Applicant: Peter Worthington; MWF Properties Bloomington  
Consultant: Dave Knaeble; Civil Site Group  
Project: Lyndale Avenue Flats Multifamily Housing Construction  
Location: 9320 Lyndale Avenue South: Bloomington  
Rule(s): 4 and 5  
Reviewer(s): LLH/BCO

**LYNDALE FLATS APARTMENTS**

Primary chemicals of concern: tetrachloroethylene (PCE) and trichloroethylene (TCE)

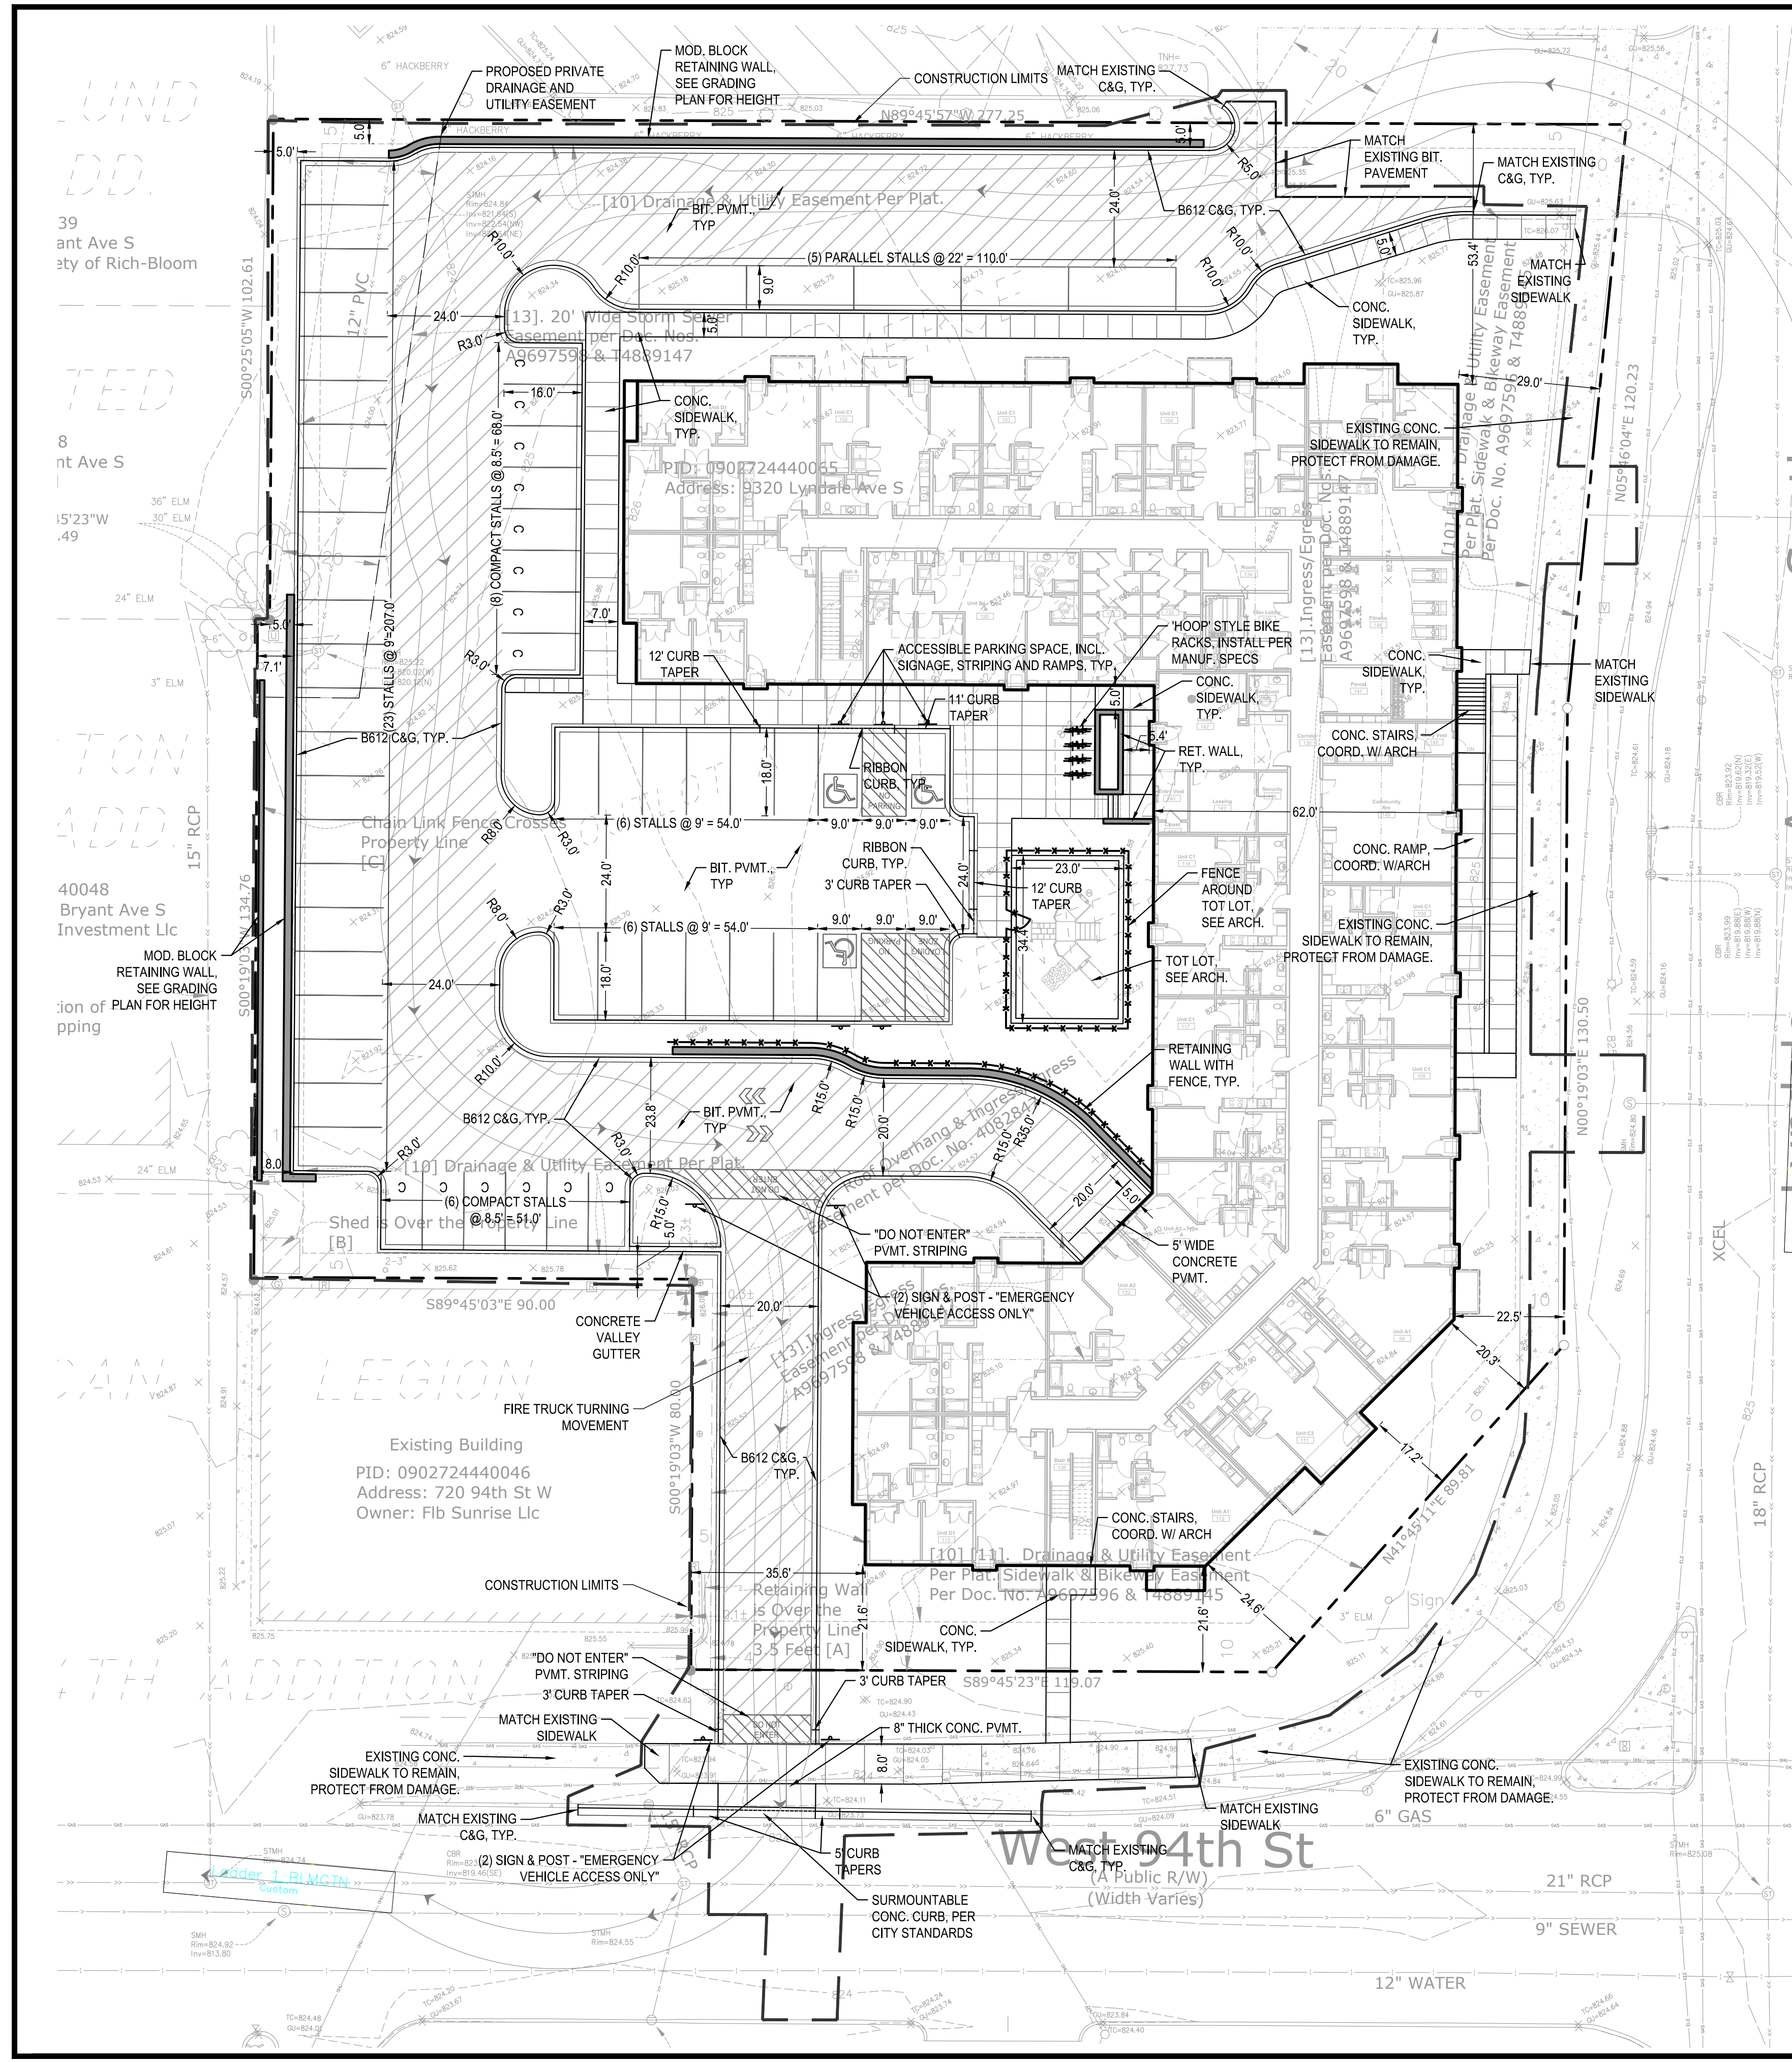
The site is within the boundaries of a subsurface contamination site with associated vapor concerns, the Lyndale Avenue Corridor Site, as shown in the attached figure. Infiltration within the vapor intrusion area of concern boundary would likely mobilize contamination into and through groundwater, facilitate the release of vapors into the soil (which may enter nearby buildings), and pose health risks to the people living and working in the buildings.
